**COUNCIL OF
THE EUROPEAN UNION**

12658/13

COMMISSION DIRECTIVE/EU

amending for the purposes of adapting to technical progress, Directive 97/24/EC of the European Parliament and of the Council on certain components and characteristics of two or three-wheel motor vehicles, Directive 2002/24/EC of the European Parliament and of the Council relating to the type-approval of two or three-wheel motor vehicles and Directive 2009/67/EC of the European Parliament and of the Council on the installation of lighting and light-signalling devices on two- or three-wheel motor vehicles

Figure 1: Pollutant emission sampling for Euro 3 as compared with Euro 2 for an L1e, L2e or L6e category vehicle

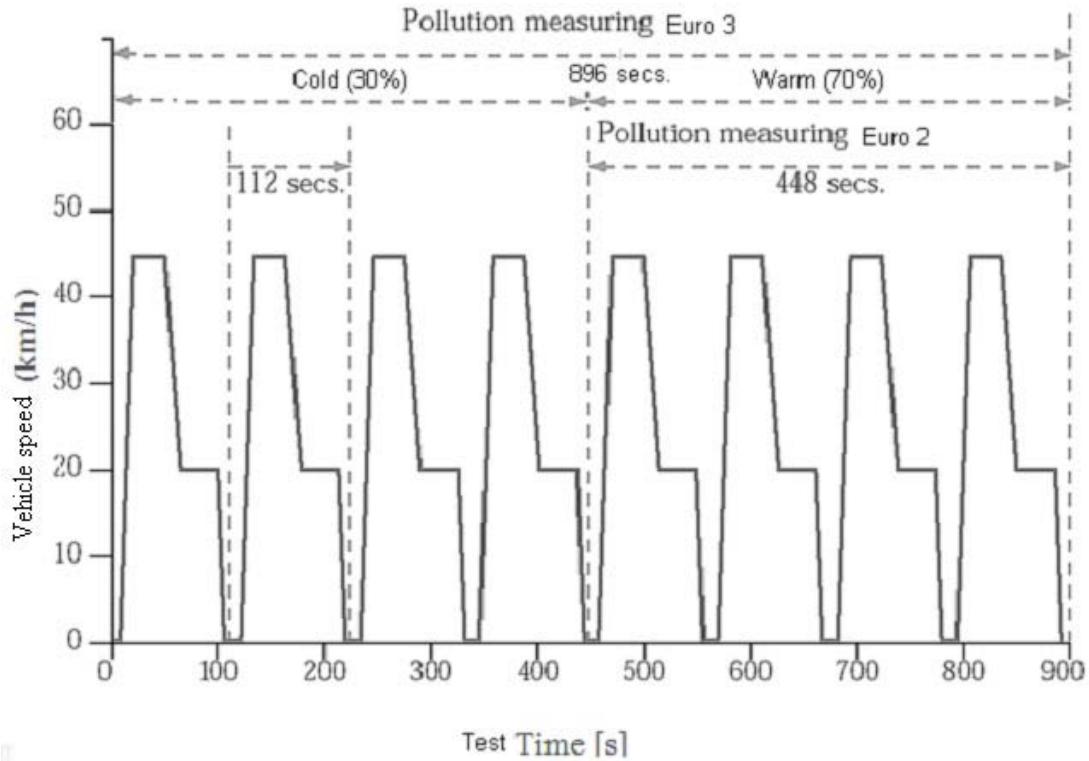
(b) In Appendix 1, points 4.2. to 4.2.3. are replaced by the following:

The gas-collection equipment shall consist of the following components (see Sub-Appendices 2 and 3):

4.2.1. A device to collect all the exhaust gases produced during the test, whilst maintaining atmospheric pressure at the moped exhaust outlet (s);

- 4.2.2. A tube connecting the exhaust-gas collection equipment and the exhaust-gas sampling system. This connecting tube and the gas collection equipment shall be made of stainless steel, or of another material which will not affect the composition of the gases collected and will resist their temperature;
- 4.2.3. A device to suck in the diluted gases. This device shall guarantee constant flow of a sufficient volume to ensure that all the exhaust gases are sucked in;

- 4.2.7. Leak-tight sampling bags to collect the mixture of exhaust gas and dilution air. These shall be unaffected by the pollutants concerned and of sufficient capacity not to disrupt the normal flow of sampling. There shall be at least one separate sampling bag (bag No 1) for cold test phase 1 and one separate sampling bag (bag No 2) for warm test phase 2;

- 4.2.7.1. These sampling bags shall each have an automatic sealing device which can be closed rapidly and tightly, either on the sampling circuit or on the analysis circuit at the end of the test.

- 4.2.7.1.1. The sealing device on bag No 1 shall close after 448 seconds after the start of the type I test.
 - 4.2.7.1.2. The sealing device on bag No 2 shall immediately open subsequent to the sealing of bag No 1 and close again 896 seconds after the start of the type I test;
